Product Change Notification

110182 - 01

Change Notification #: 110182 - 01
Change Title: Intel® Server Board S3420GPLC, S3420GPLX, S3420GPRX, S3420GPV and Intel® Server System SR1630GP, SR1630GPRX, SR1630HGP, SR1630HGPRX, PCN 110182-01, Documentation, Update Intel(R) System Management Software CD and Attention Document; Update PSU of Intel® Server System SR1630GPRX and SR1630HGPRX, Reason for Revision: Intel(R) Server System SR1630GPRX and SR1630HGPRX Power Supply Unit P1 cable length change
Date of Publication: October 13, 2010

P1 Cable

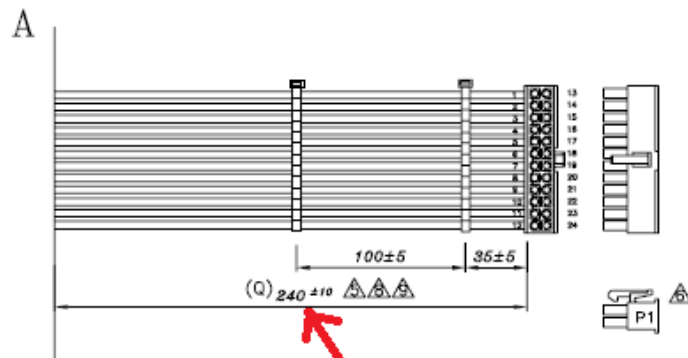
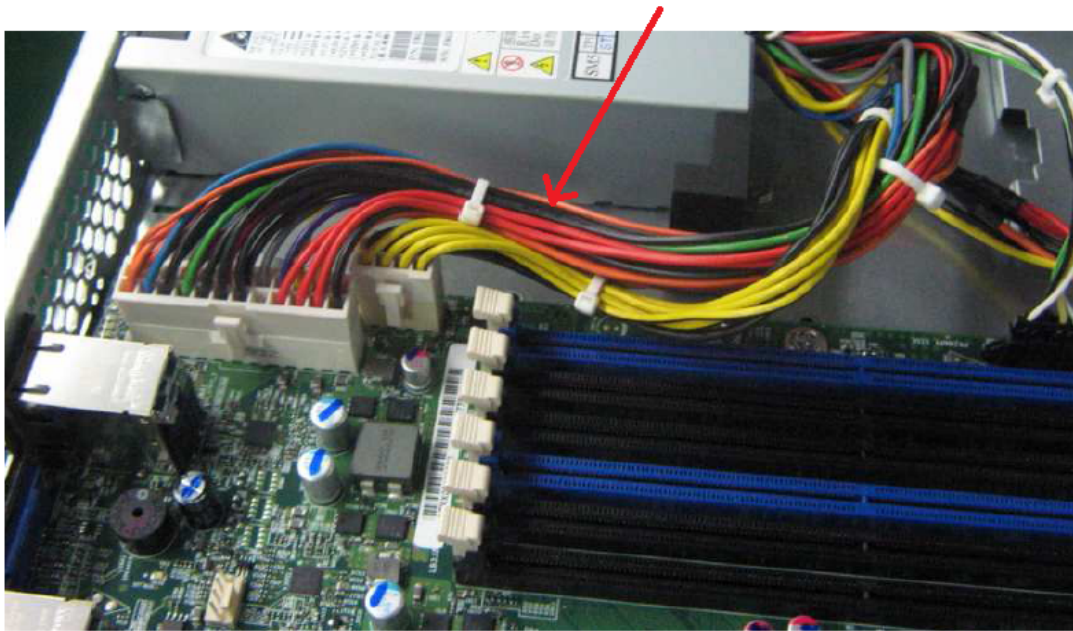
6) The Power Supply Unit of The Intel(R) Server System SR1630GPRX and SR1630HGPRX is being updated from E86365-003 to E86365-004 to including the following change

- The P1 cable length is changing from 230±10mm to 240±10mm. See the photos below for more details.

P1 Cable length is changed from 230±10mm to 240±10mm
